CHANGES FROM BASE PRODUCT AC-24-12(001) (4235) TO AC-24-12(007) (4762)

Assembly PI Approval S.ATTWOOD 23/12/14		Approved by B.JOHN		Checked by M.POTTER		Drawn by P.MISSEN	
Angle of Projection 		Units mm	Scale N/A	Released 02/01/15		Assembly Ref -	
Third Angle		Status RELEASED		AC-24-12(007)			
		Part No 4762		BE-003026-00-14

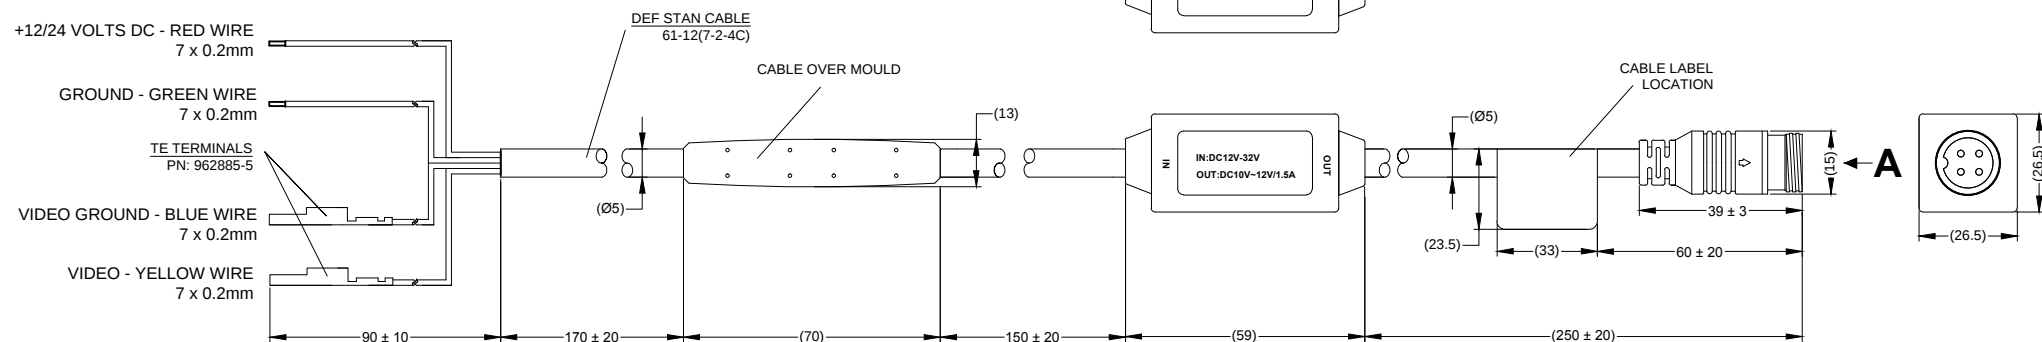
- CHANGE:
1. REPLACE 4 PIN MALE MINI DIN CONNECTOR WITH OVER MOULDED 4 CORE CABLE.
 2. TE CRIMP TERMINALS ADDED.
 3. APPLY AC-24-12(007) CBL-LBL OVER MODEL NUMBER AND PART NUMBER ON AC-24-12(001) CBL-LBL.
 4. REPLACE AC-24-12(001) GB-LBL WITH AC-24-12(007) GB-LBL.
 5. INSTALLATION GUIDE AC-24-12(007)-IG (4841) ADDED.
